INCH-POUND
MIL-P-24691/3
AMENDMENT 1
4 February 1991

PIPE AND TUBE, CORROSION-RESISTANT,
STAINLESS STEEL, SEAMLESS OR WELDED

This amendment forms a part of MIL-P-24691/3, dated 23 September 1987, and is approved for use by all Departments and Agencies of the Department of Defense.

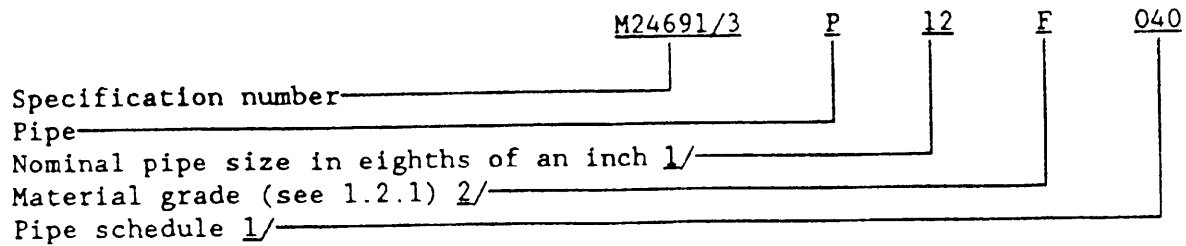
1.2.2: Delete and substitute:

"1.2.2 Part number.

1/ Pipe shall be ordered to nominal pipe size and schedule as specified in ANSI B36.10.

- 2/ F - TP304
 G - TP304L
 H - TP304N
 J - TP316
 K - TP316L
 L - TP316N
 M - TP317
 N - TP317L
 P - TP321
 Q - TP347

Example: M24691/3 pipe 1-1/2 inch nominal pipe size, low carbon schedule 40."
